**AGENDA**  
**WORCESTER TOWNSHIP PLANNING COMMISSION**  
**WORCESTER TOWNSHIP COMMUNITY HALL**  
**1031 VALLEY FORGE ROAD, WORCESTER, PA 19490**  
**THURSDAY, NOVEMBER 10, 2022, 7:00 PM**

Reference: Kerper Minor Subdivision (LD 2022-04)

RE: Kerper Minor Subdivision (LD 2022-04)  
Worcester Township, Montgomery County  
Waiver Request Letter

RE: **Traffic Review #3 - Transportation Impact Assessment/Preliminary Subdivision Plans/Highway Occupancy Permit Plans**

FIELD PERSONNEL: RPB/MEP  
SHEET TITLE: MINOR SUBDIVISION PLAN  
DESIGNED BY: MEP  
DRAWN BY: MEP  
CHECKED BY: MEP  
PROJECT NO.: KERPB0001  
DATE: 4/11/22  
PLAN SCALE: 1" = 40'  
CADD FILE: KERPER-HEEBNER-MODEL  
SHEET NO.: 1 OF 1

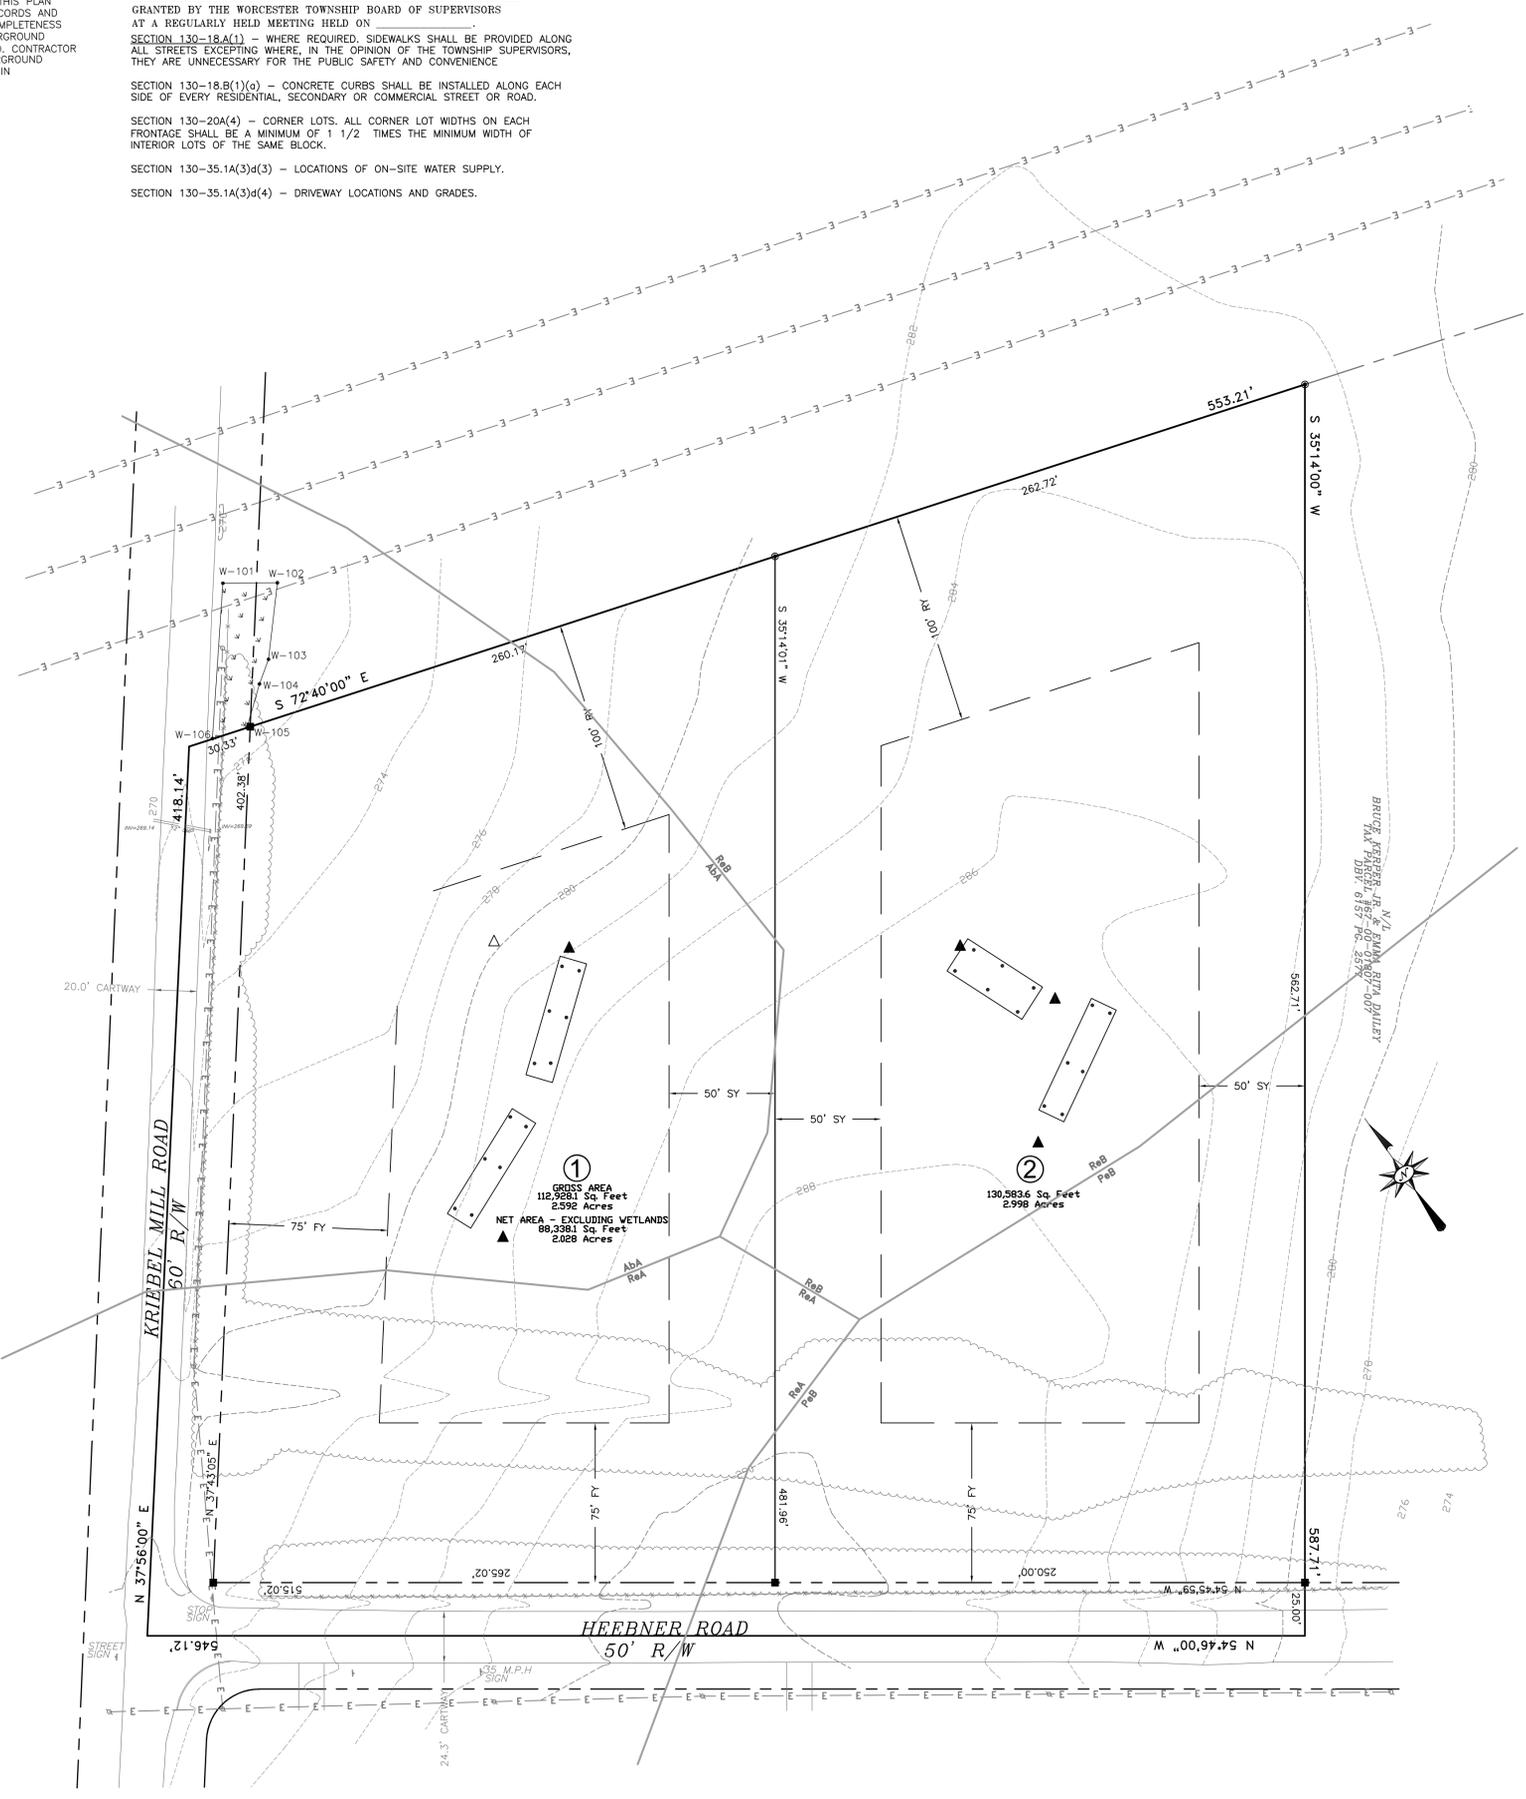
1. The ordinance requirements for minor subdivision plans require that the location and slope of driveways be shown on the plan. This is required by Section 130-35.1A(3)d(4). Since the applicant is showing no improvements on the lots at this time, a waiver has been requested for this requirement.

2. Section 130-35.1A(3)d(3) requires the plan to show the water supply features (wells) on the plan. There are no well locations shown on the plan. The applicant has requested a waiver for this requirement.

3. Section 130-20A(4) requires a corner lot width for both frontages to be 1 ½ times the minimum width required by zoning. Since the zoning requires a minimum width of 250 feet, the frontages on both Kriebel Mill and Hebner Roads should be 375 feet. Lot 1 only provides 265 feet along Hebner Road. The applicant requested a waiver from this requirement.

4. The applicant is requesting a waiver for road frontage improvements, sidewalks, and curbing. (Sections 130-18A (1) and 130-18B(1)(a).)
5. A letter with all waiver requests was submitted, dated September 2, 2022, and is attached to this letter. All waivers will need to be considered by the Township.

A waiver is requested for relief from providing sidewalks due to the minor nature of the project and there are no sidewalks to connect to in the surrounding area.

A waiver is requested due to the minor nature of the project, and there is no need for curbing along this road.

A waiver has been requested as a future buyer will decide where to put the driveway as they complete the building permit phase.

A waiver has been requested as a future buyer will decide where to put the driveway as they complete the building permit phase.

A waiver has been requested to provide relief for the lot width on Heebner Road, the width has been set at the maximum available space. No relief is needed along Kriebel Mill Road as it is more than the 1 ½ times requirement.
